<b>DRM(B) 26547/16-F</b>		<b>PCE e-29083-DRM-1/D</b>	
<b>DEDICATED FREIGHT CORRIDOR CORPORATION OF INDIA LIMITED</b>			
<b>CONSIGNEES</b> <b>THE CHIEF PROJECT MANAGER</b> DEDICATED FREIGHT CORRIDOR CORPORATION OF INDIA LTD. (A Government of India Undertaking) 7TH FLOOR, CENTRAL RAILWAY NEW ADMIN BUILDING, ON ROAD MUMBAI - 400001		<b>WESTERN RAILWAY</b> OFFICE OF CHIEF BRIDGE ENG. 2ND FLOOR, GED BUILDING, CHURCHGATE, MUMBAI	
<b>CONSULTANT:</b>  <b>GED TEST HOUSE</b> PVT. LTD.	(A Division of GED DESIGNS AND RESEARCH PVT LTD) 101, KANHAIYA INDUSTRIAL ESTATE, OFF. B.L.D.C. GORWA ESTATE, KANDHAWA - 390 016 TELEFAX : 91-265-2202022,2226361 E-Mail: design@gedengg.com		
<b>TITLE:</b> <b>GENERAL ARRANGEMENT DRAWING</b> <b>PROPOSED LIMITED HEIGHT SUBWAY (1x7.0mx4.0m) RCC BOX</b> <b>AT EXIST. LC NO. 80 AT RLY. CH. 172/16-B</b> <b>(DFC CH. 13-523.289Km) MET. STATION VAPLI- BAGWADA OF</b> <b>MUMBAI-DELHI TRUNK ROUTE OF BCT DIVISION WESTERN RLY.</b> <b>ATVU : 37,30,000 PINK BOOK NO. : _____</b>

<b>DRG. NO.</b> <b>LHS/CPM/NM/MUM/VAPLI/HS</b>		<b>REV.</b> <b>R0</b>	
		<b>DATE</b> <b>07-10-2020</b>

CROSS SECTION OF U-TYPE WALL AT  
WITHOUT PIER LOCATION

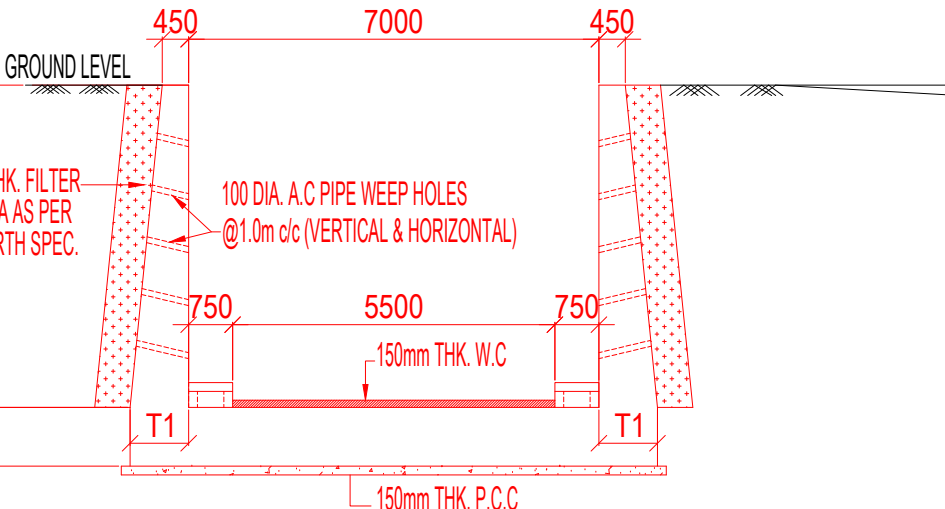
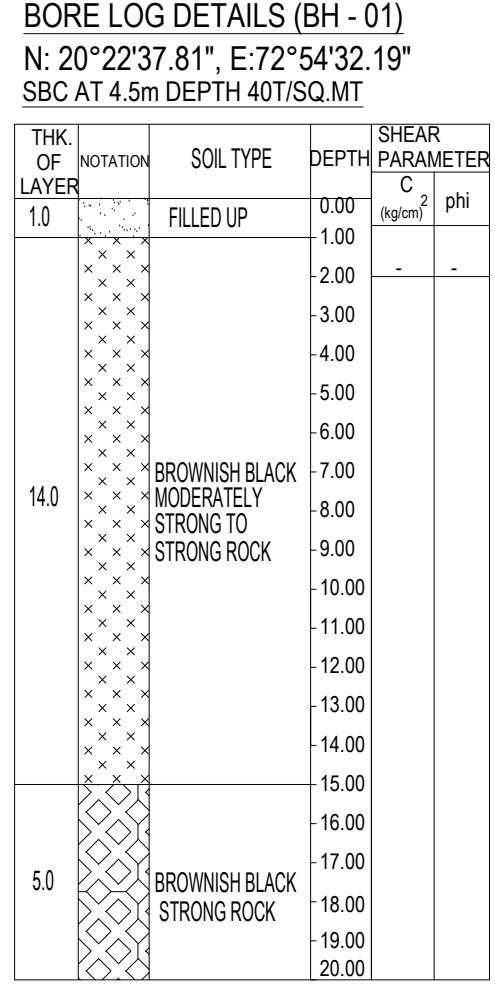
1. PRIOR COMMENCING THE WORK SITE ENGINEER/DFCCIL OFFICIALS/DEN TO ENSURE THAT BOX CAN BE PUSHED AS SHOWN IN ELEVATION THAT IS FROM 15.5M AWAY THRUST BED IS FEASIBLE, IF NOT THRUST BED SHALL BE CAST TOWARDS LOOP LINE ON EAST SIDE BY IMPOSING SR 20 KMPH.
2. SUITABLE MICRO PILING SHALL BE PROVIDED AS MENTIONED IN OPERATION 2 OF PHASE WORK.
3. PRIOR COMMENCING THE WORK SITE ENGINEER/DFCCIL OFFICIALS/DEN TO ENSURE THE FEASIBILITY OF THE PROPOSAL.

① The size of work is not as  
RPO standard available day,  
hence kindly reduce the size  
as per RPO. Drop or submit details  
design to, not office & take  
approval from the office before  
execution of work.
